Project No. 25-0067.00

June 11, 2026

ADDENDUM NO. 3
TO THE
DRAWINGS AND PROJECT MANUAL
FOR
NEW OPPORTUNITY AWARENESS CENTER
KATY INDEPENDENT SCHOOL DISTRICT
KATY, TEXAS

SHEET NO.
C5.00

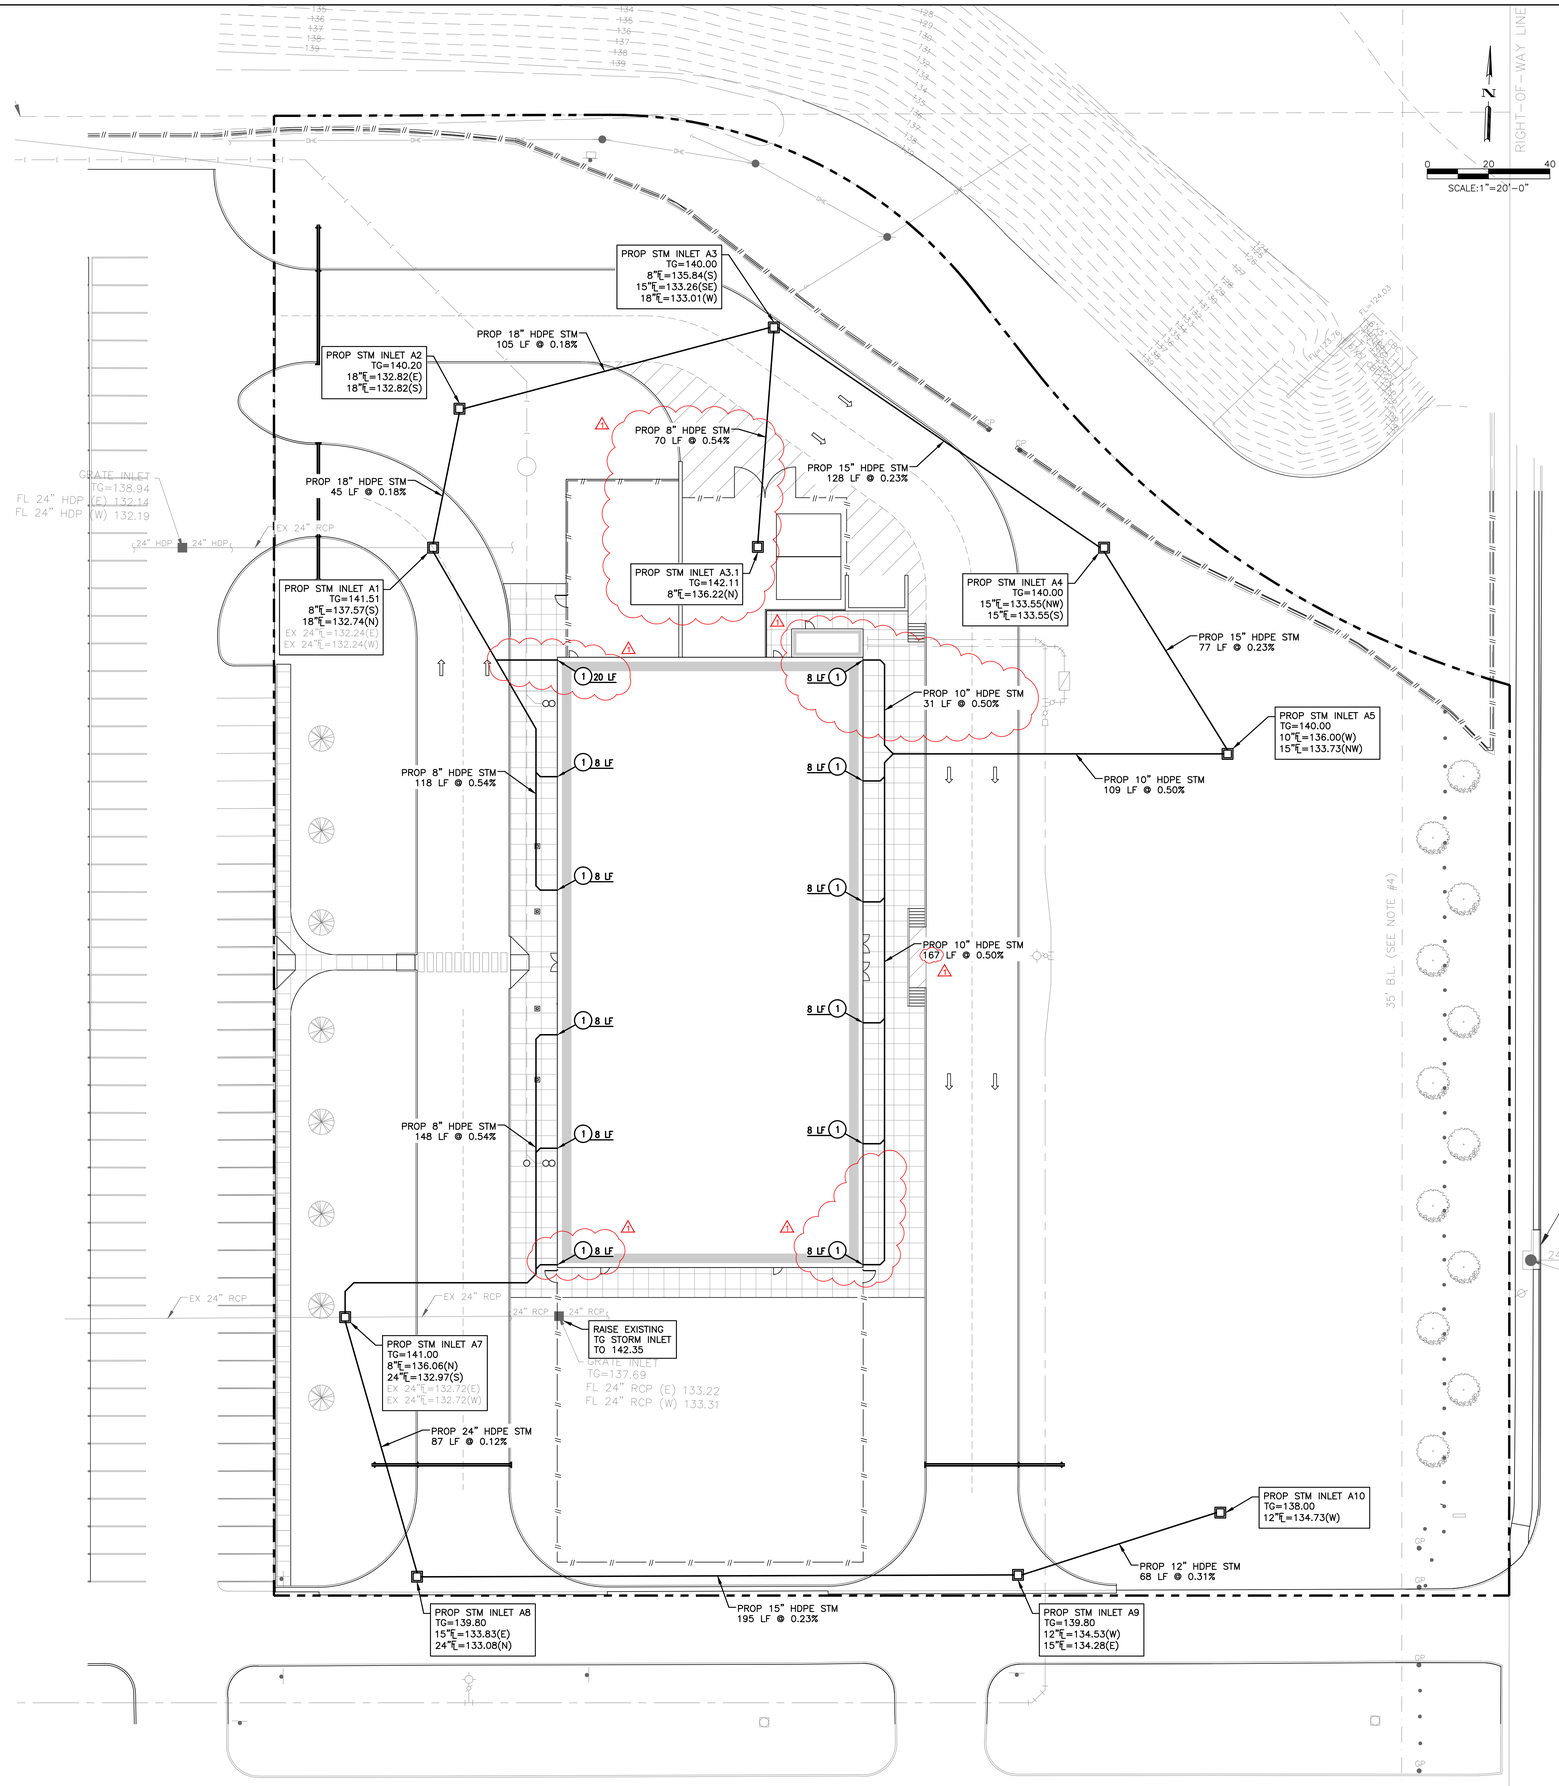
1. C5.00 - SITE UTILITY PLAN

A. Revised 6-inch fire line connection and 4-inch domestic water line connection to building, to accommodate the addition of the pump room.

SHEET NO.
C7.00

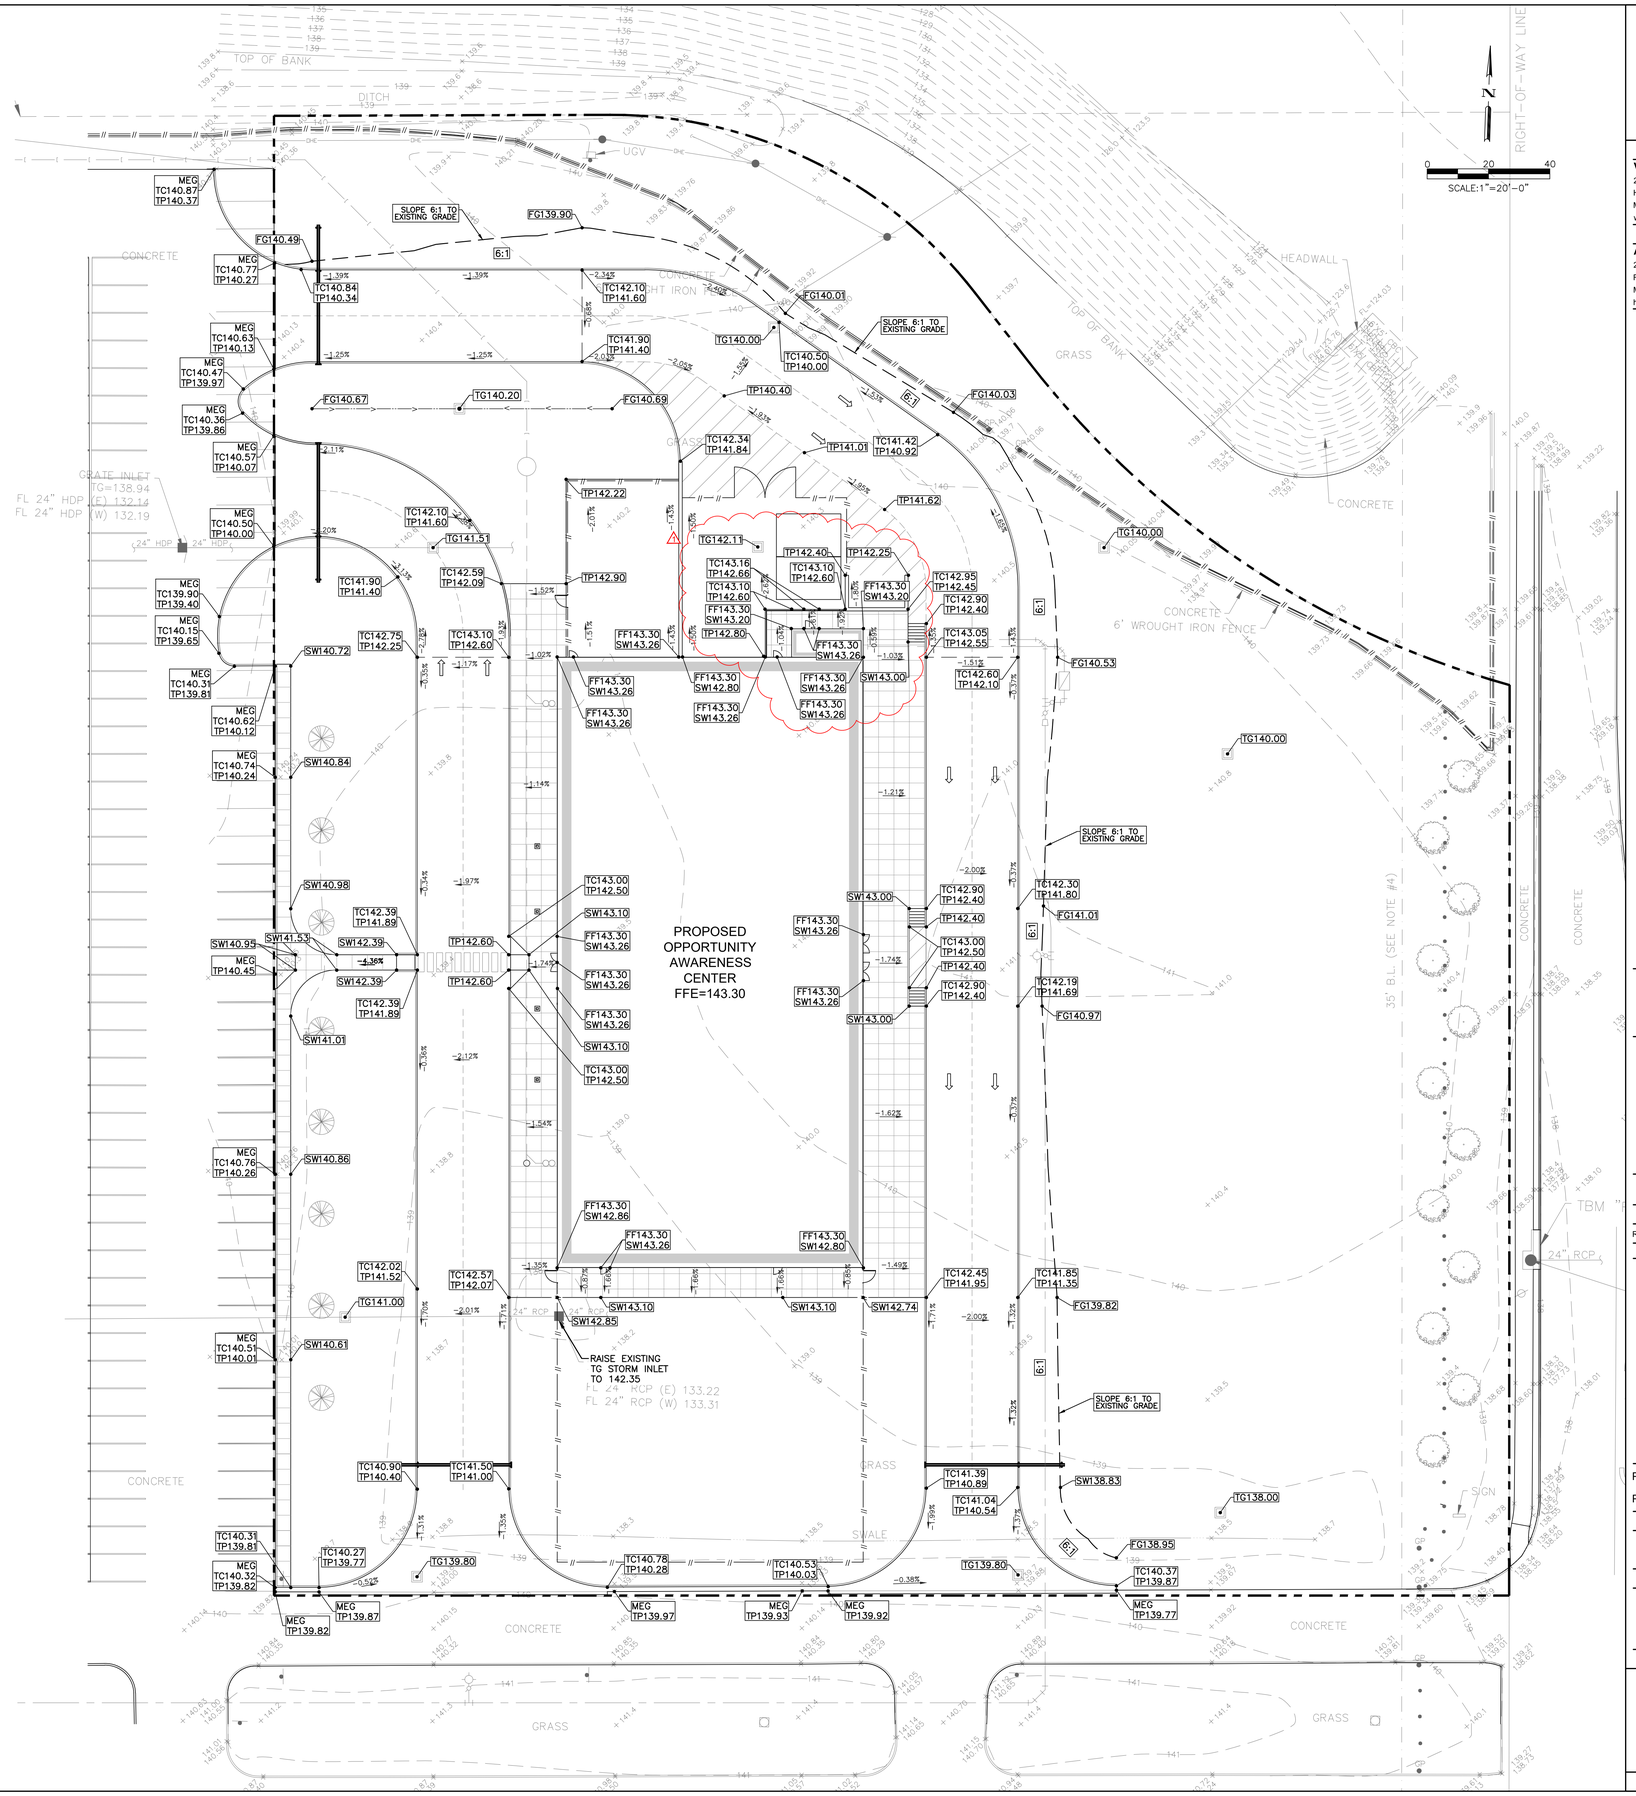
3. C7.00 - GRADING PLAN

A. Revised grading around the new pump room addition.

SHEET NO.
S2.00

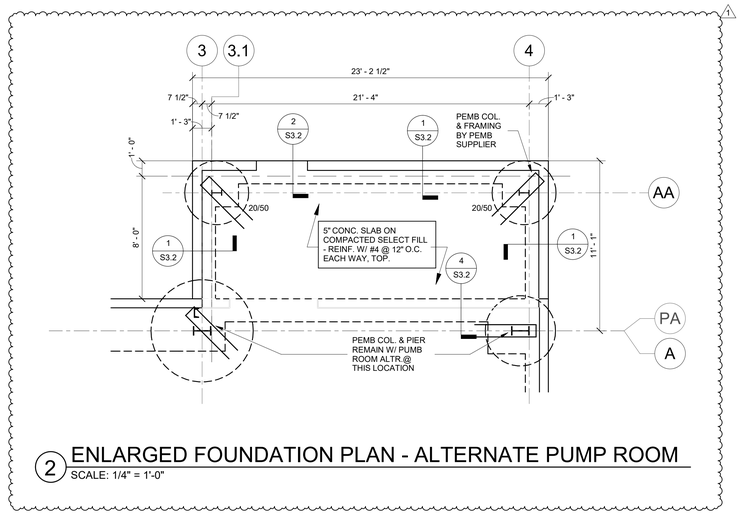
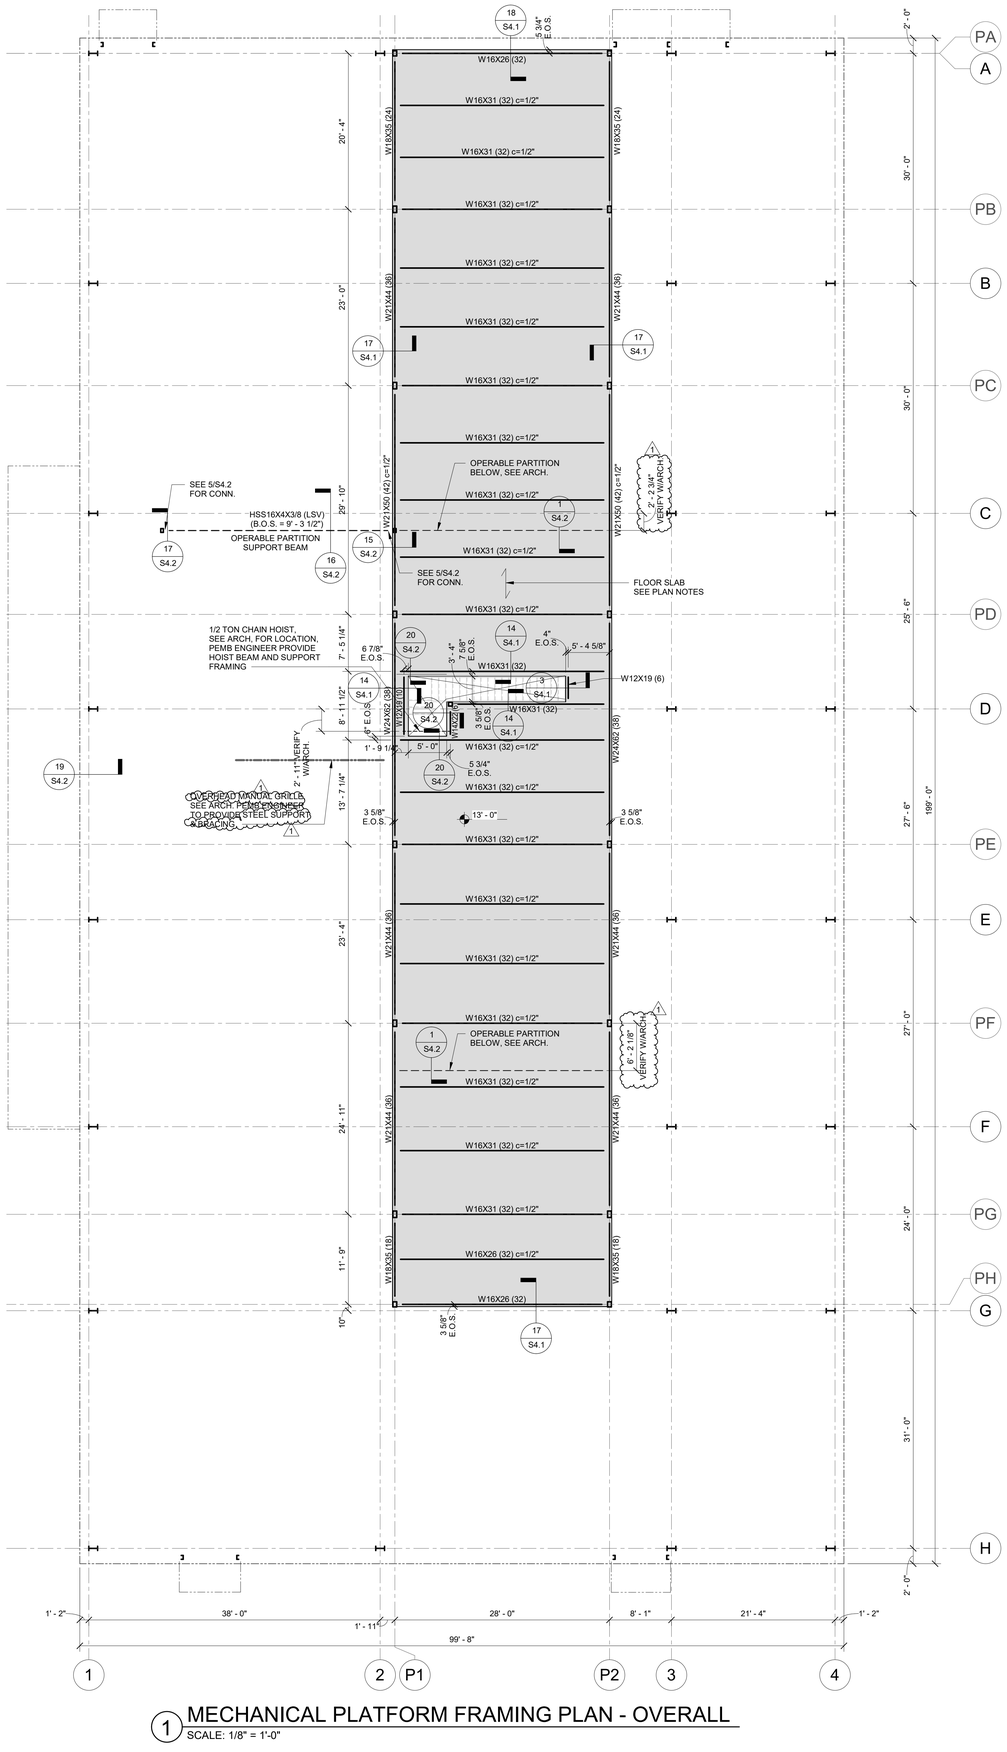
1. **S2.00-Founation Plan-Overall**
   - A. Add enlarged foundation plan for alternate pump room.
   - B. Clarify contraction joint spacing at polished concrete.

4 MECHANICAL YARD - ALTERNATE

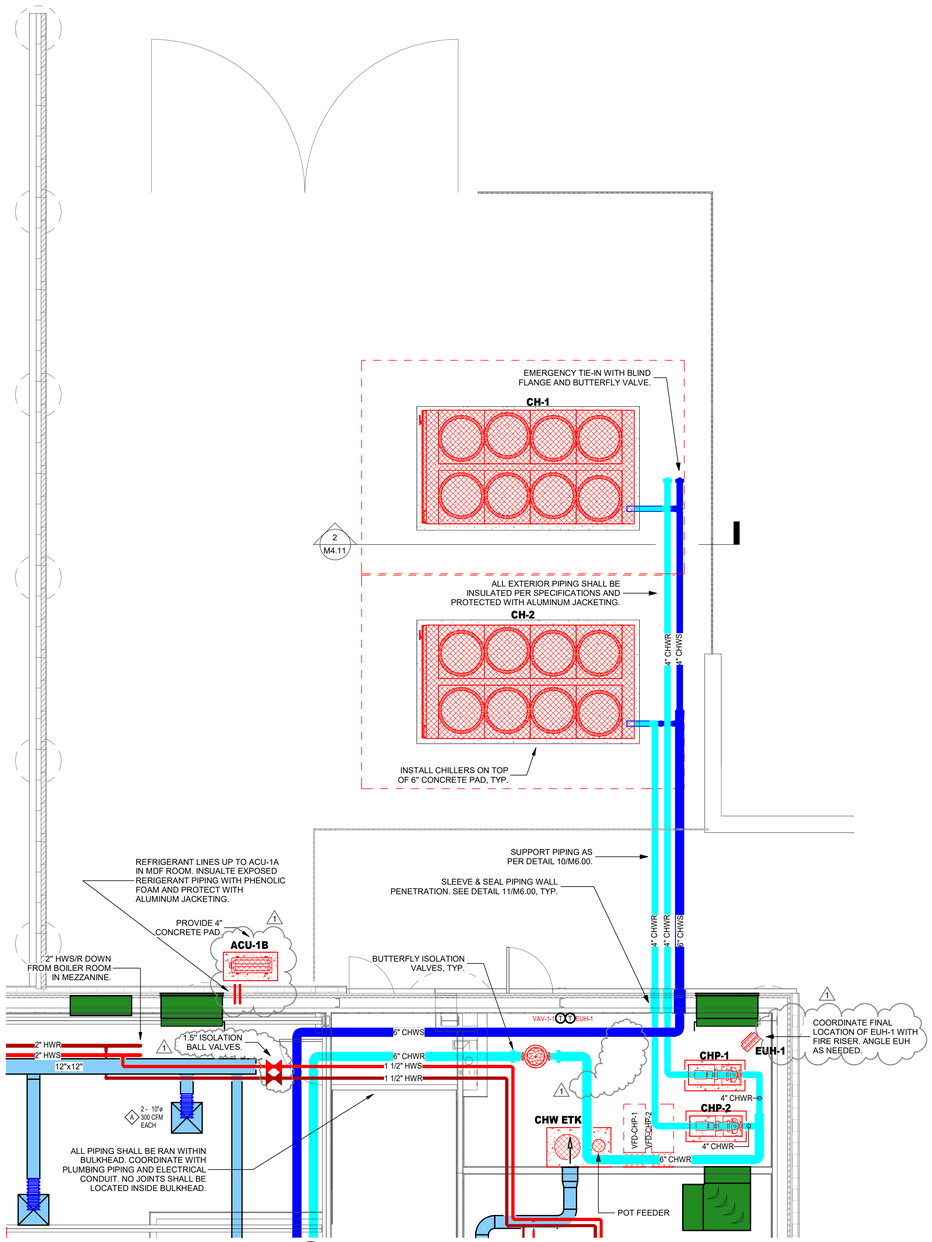
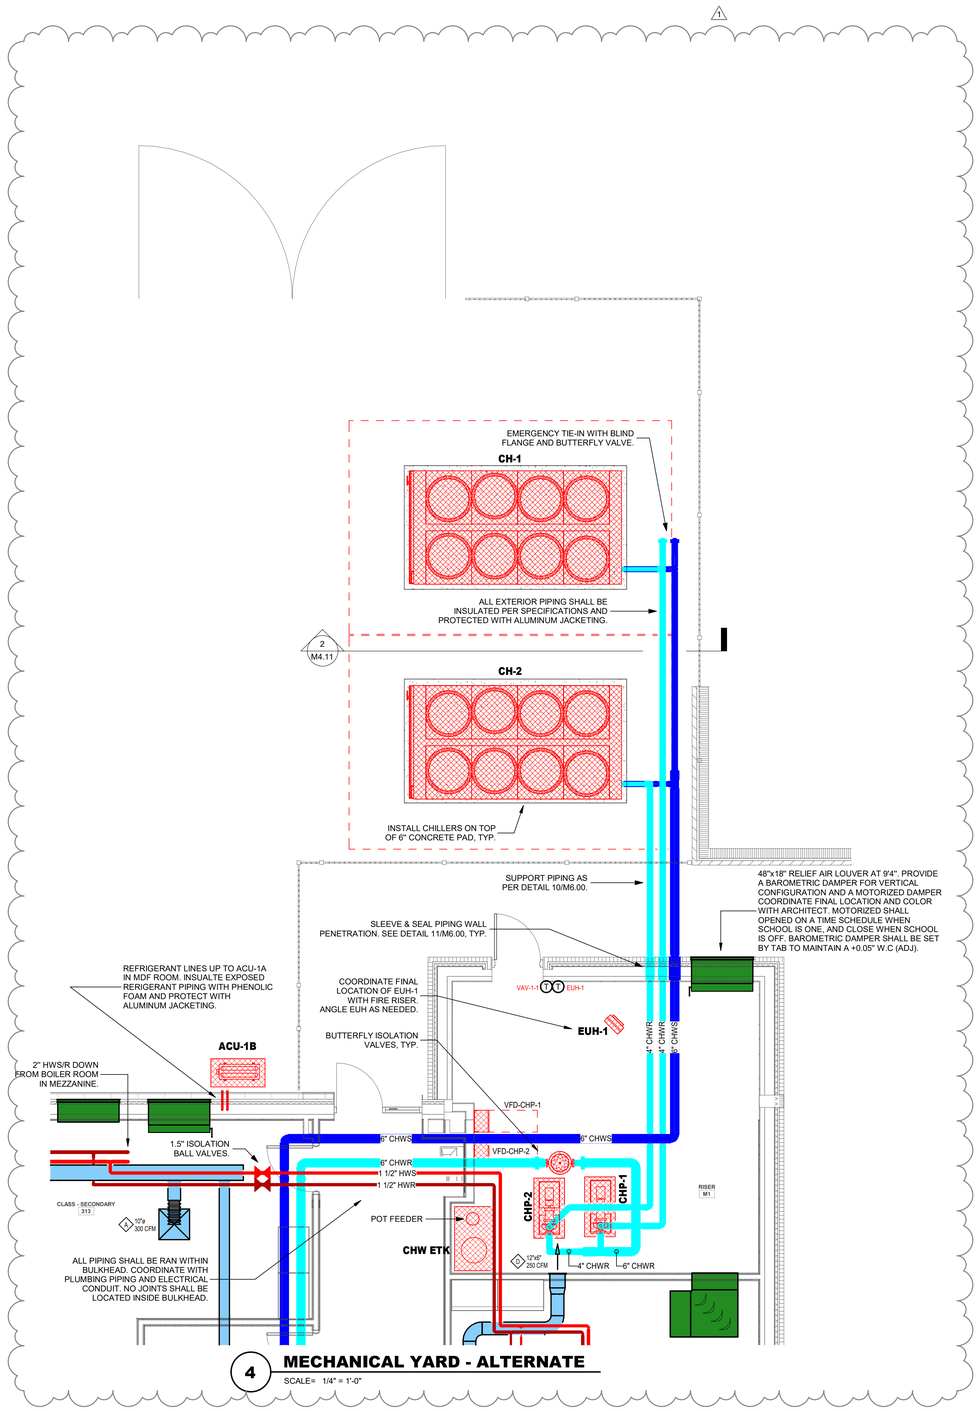
7. SHEET M4.11 – MECHANICAL YARD

B. Added notes to coordinated EUH-1 location.
